**SUBMITTAL TO THE FLOOD CONTROL AND
WATER CONSERVATION DISTRICT BOARD OF SUPERVISORS
COUNTY OF RIVERSIDE, STATE OF CALIFORNIA**

SUBJECT: Approve Contract Change Order No. 1, Little Lake MDP Line B, Stage 1,
Project No. 4-0-00265-01, District 3, [\$162,916] 100% District Funds

Project: Little Lake MDP Line B, Stage 1
Project No. 4-0-00265-01

CONTRACT CHANGE ORDER NO. 1

ADDITIONAL PAVING LIMITS

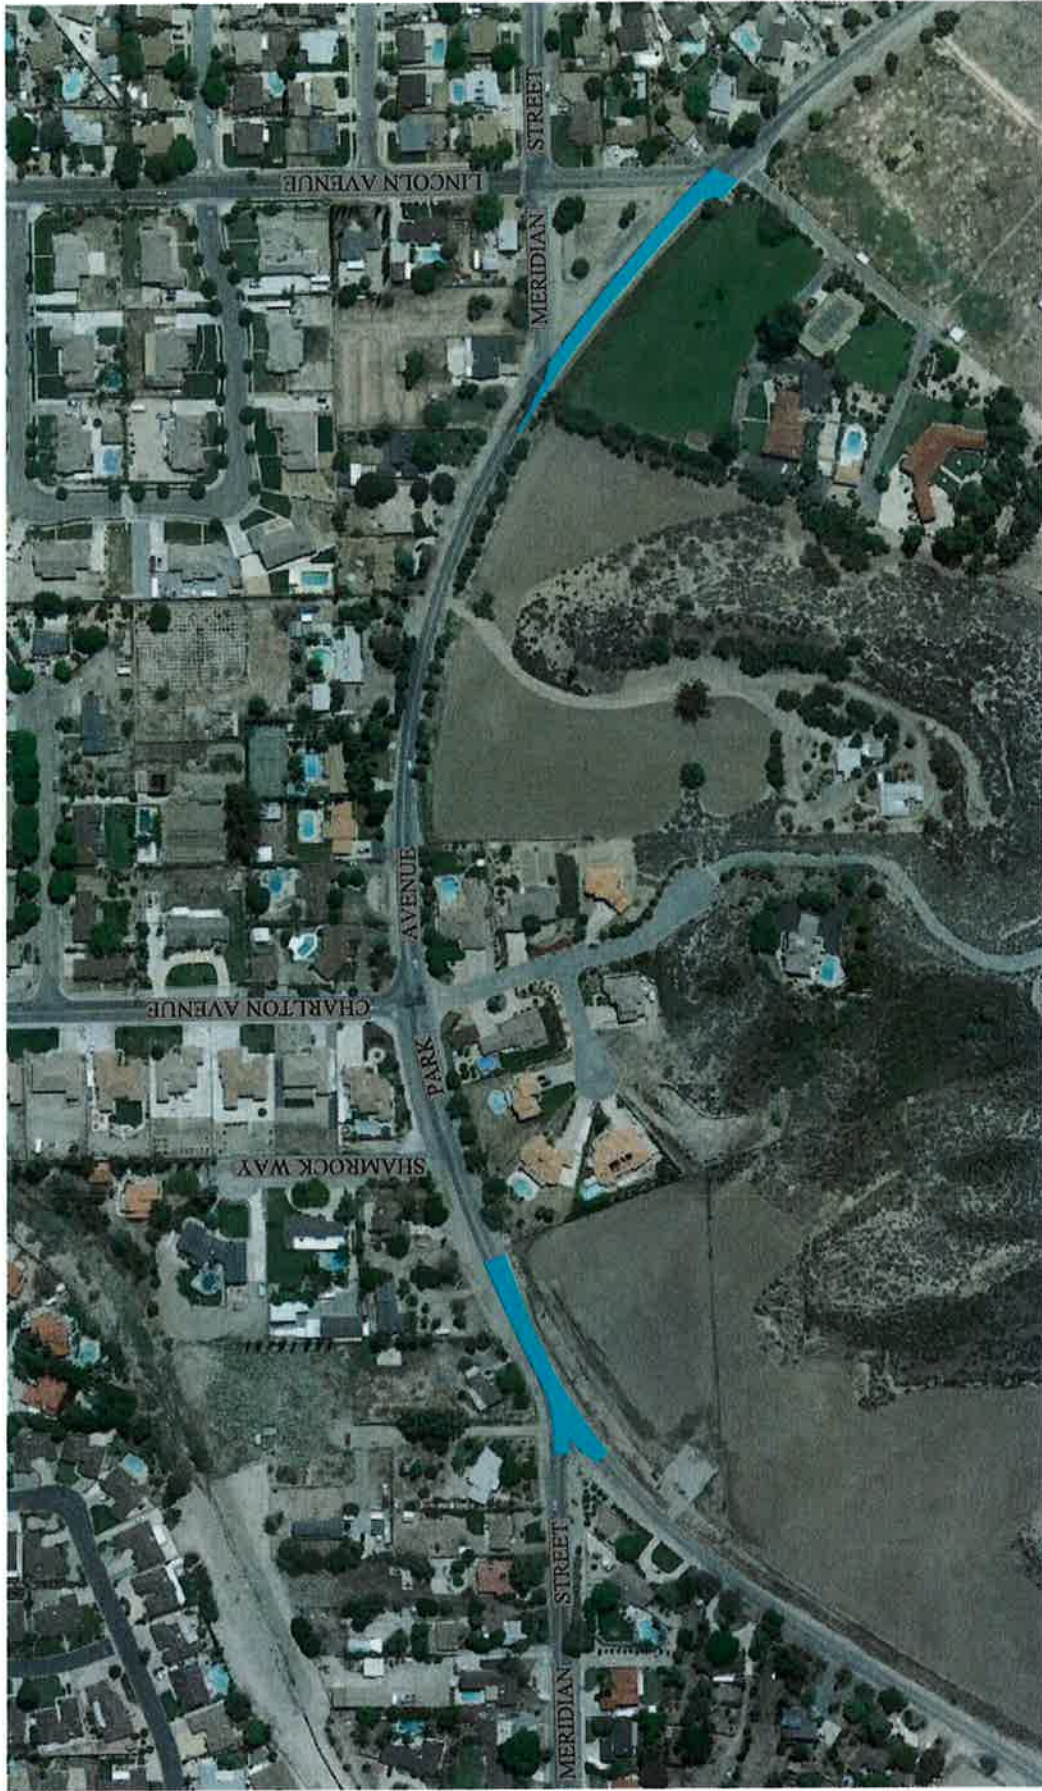
Change Order No. 1 Technical Summary - The original project paving and earthwork plan indicates that hot mix asphalt (HMA) and aggregate base (AB) are to be replaced over the storm drain trench limits along Park Avenue and Meridian Street. The plan also shows that the remainder of the existing streets is to receive a 1.5" HMA grind and overlay.

After the storm drain construction through the intersection of Park Avenue and Meridian Street near Lincoln Avenue, the existing street was in such poor condition that it was deemed undrivable. The entire street width near the intersection required full AB and HMA replacement.

The street paving described above requires the placement of an additional 586.6 cubic yards of AB and 468.9 tons of HMA.

This change order covers the additional hot mix asphalt (HMA) and Class II Aggregate Base needed to restore Park Avenue to an acceptable driving condition. The District and the City of Hemet worked together to determine the restoration limits and the required pavement section. The approved Plans and Specifications did not identify this work.
